Re: Ecology Comments of Supplemental Remedial Investigation Report

- **Site Name:** Coleman Oil Biodiesel Spill
- **Site Address:** 3 E Chehalis St., Wenatchee, Chelan County
- **Facility/Site ID:** 83844381
- **ERTS ID No.:** 671575
- **Agreed Order No.:** DE 15389

Ecology Comments on Coleman Oil Company Biodiesel Spill Site

Draft Supplemental Remedial Investigation (SRI) Report

Section 5.6.4 – Figure 8 - Staff Gauge Water Levels and Product Thickness

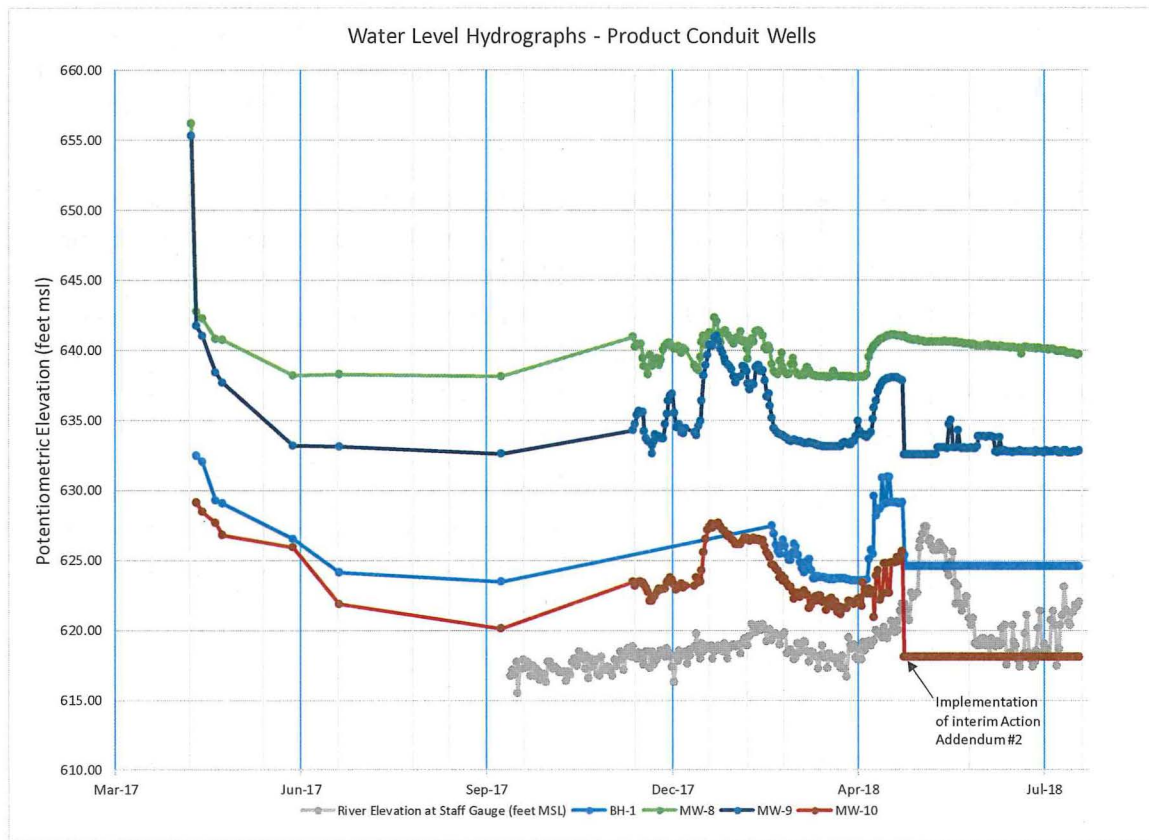
This figure is a scatter plot of river elevation versus product thickness in monitoring wells MW8, MW9, MW10, and BH1. It is unclear whether or not a relationship is being asserted. Cross sections and water level hydrograph data would appear to eliminate a causal relationship between river levels and groundwater or product levels, except perhaps during the one month period in May when river levels are very high. Only during a one month period in May is the river losing. Most of the year the river is gaining. During this time, a localized effect on river and groundwater levels and/or product thickness may be evident in the vicinity of MW10 may be evident. The requested revisions to the cross sections (see comments on Figures, below) should make this relationship more clear.

Of potential greater relevance would likely be the relationship between groundwater level elevation and product thickness. However, product recovery efforts make this relationship difficult to assess.

We recommend removing Section 5.6.4 and Figure 8 if there is no significant causal relationship between river stage and product thickness in monitoring wells MW-9, BH-1, and MW-10. Instead, a section is needed in the SRI Report discussing groundwater and river levels over time, period of river loss and gain, and the potential effects on contaminant transport.

For example, when a groundwater level drops below a conduit level in a monitoring well (see comment on Section 5.7.1.), then product transport in the conduit should cease. This section should include a groundwater level hydrograph similar to the following:

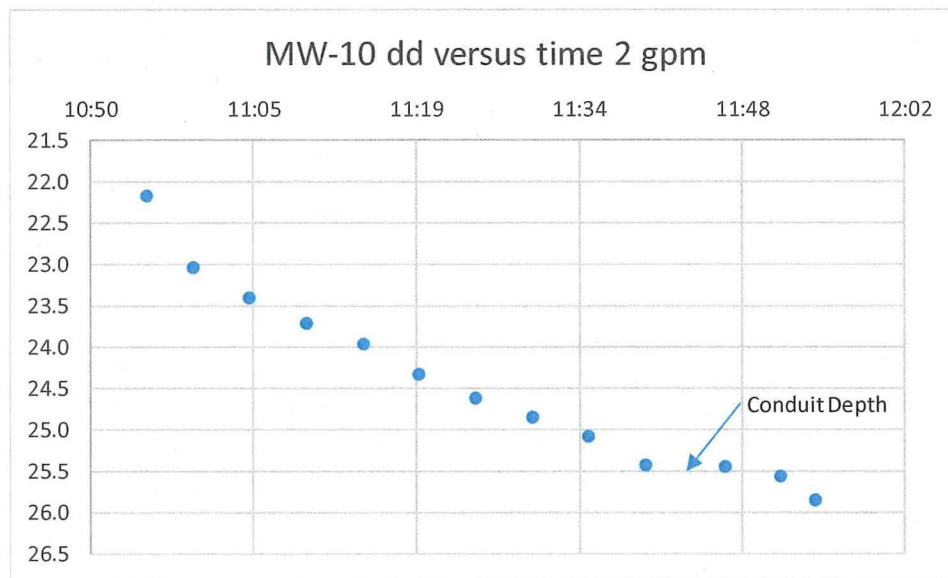
Please include the drawdown and recovery versus time charts for MW9, MW10, and BH1 and include discussion of the observed higher transmissivity (conduit) intervals at each well. An example of a conduit at 25.5 ft bgs in MW-10 based on manual water level measurements is shown below:

Figure 13 and 13 – Potentiometric Surface Maps

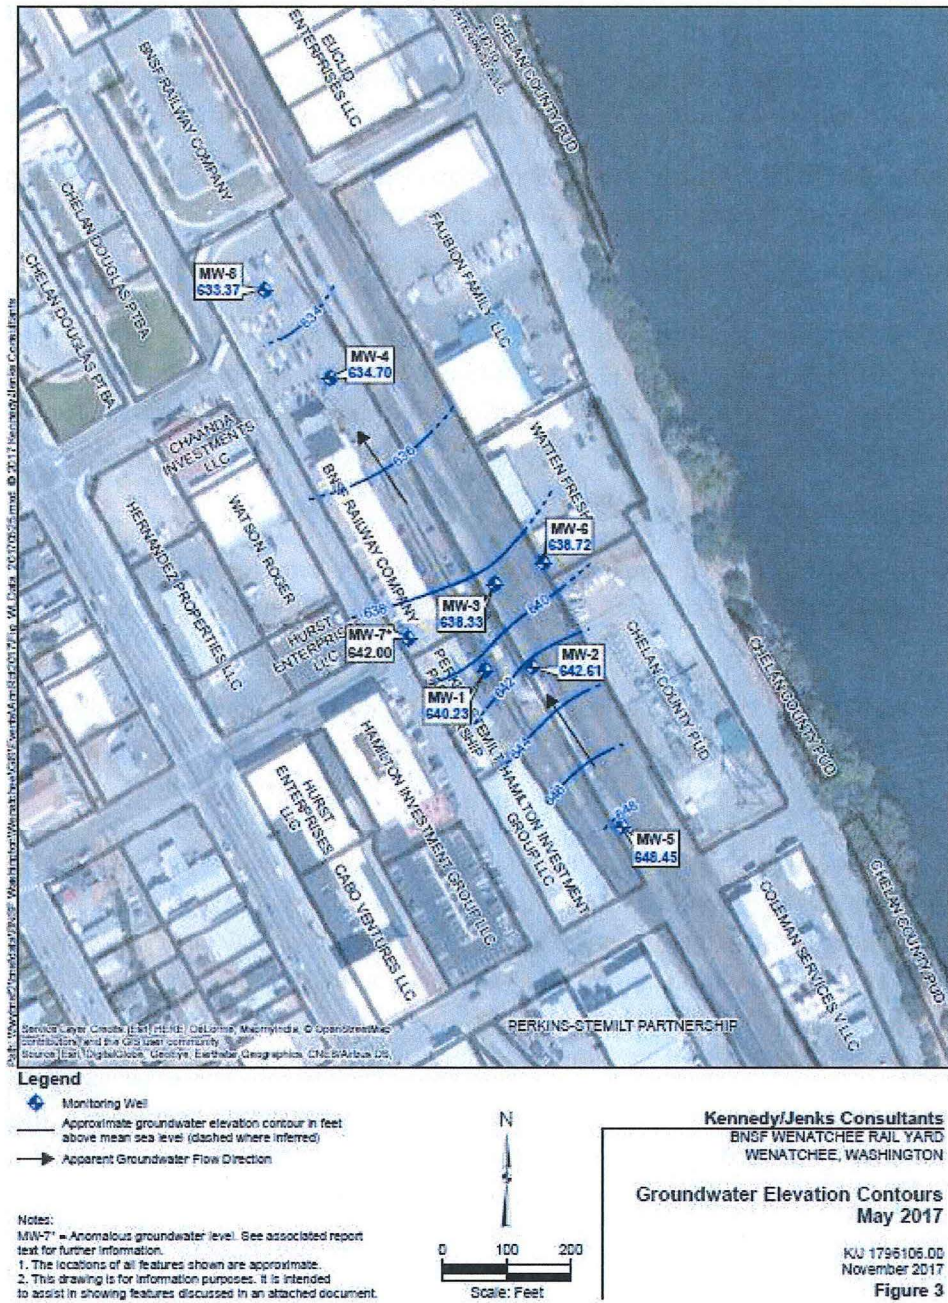
We suggest making the contours in the area underneath the Chelan PUD property to the north dashed, since contours may curve more to the west in this area. This contour curvature is suggested by potentiometric surface maps from the BNSF Railyard site located to the northwest (groundwater flows to the north-northwest in that area, parallel to the river). A copy of a potentiometric surface map from the BNSF site is shown below.
